ITEM: 6.3	COMMITTEE OF ADJUSTMENT REPORT SUMMARY MINOR VARIANCE APPLICATION FILE NUMBER A029/23 9 NAYLON STREET, MAPLE
------------------	---

**COMMITTEE OF ADJUSTMENT REPORT
MINOR VARIANCE APPLICATION
A029/23
9 NAYLON STREET, MAPLE**

ITEM NUMBER: 6.3	CITY WARD #: 1
APPLICANT:	Bijal Patel & Seema Mahithia
AGENT:	Square Design Group
PROPERTY:	9 Naylon St., Maple
ZONING DESIGNATION:	See Below
VAUGHAN OFFICIAL PLAN (2010) DESIGNATION:	Vaughan Official Plan 2010 ('VOP 2010'): "Low-Rise Residential"
RELATED DEVELOPMENT APPLICATIONS:	None
PURPOSE OF APPLICATION:	Relief from the Zoning By-law is being requested to permit the construction of a proposed cabana and increased maximum driveway width.

1 SITE PLAN
A1 1:200

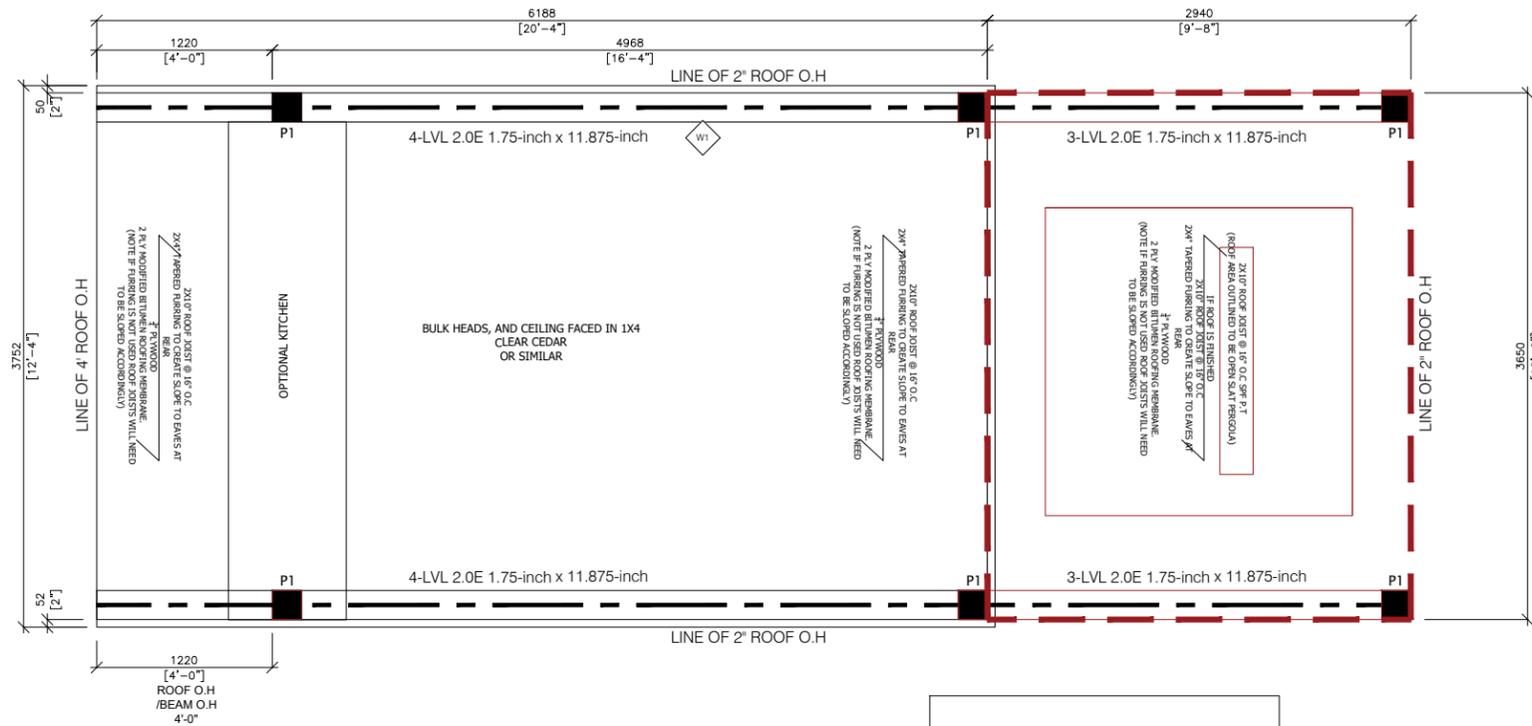
As the proposed cabana in the subject property is 34.2 m², the Owner / Applicant needs to obtain a Lot Grading Permit from Development Inspection and Lot Grading Division of the City's Development Engineering Department. Please note any in-ground structure over 10 m² requires a Grading Permit. Please contact the Development Engineering Reviewer after receiving the Grading Permit to clear the condition. (Condition attached)

The proposed work by the Owner / Applicant is increasing the lot coverage on the subject property. The added hardscape may have impacts on the City's Storm Water management system. Development Engineering strongly encourages the Owner / Applicant introduce Low-Impact Development (LID) measures (e.g., bioswales, permeable pavers, rain gardens, rain barrels etc.) to reduce the impacts to the stormwater system. Should further information be required, please contact the Development Engineering COA reviewer.

Development Engineering Recommended Conditions of Approval:	The Owner / Applicant shall submit the final Lot Grading and/or Servicing Plan to the Development Inspection and Lot Grading Division of the City's Development Engineering Department for final Lot Grading and/or Servicing Permit prior to any work being undertaken on the property. Please visit the Grading Permit page at City of Vaughan website to learn how to apply for the Grading Permit. If you have any questions about Grading Permit, please contact the Development Engineering Department by email at DEPermits@vaughan.ca.
--	--
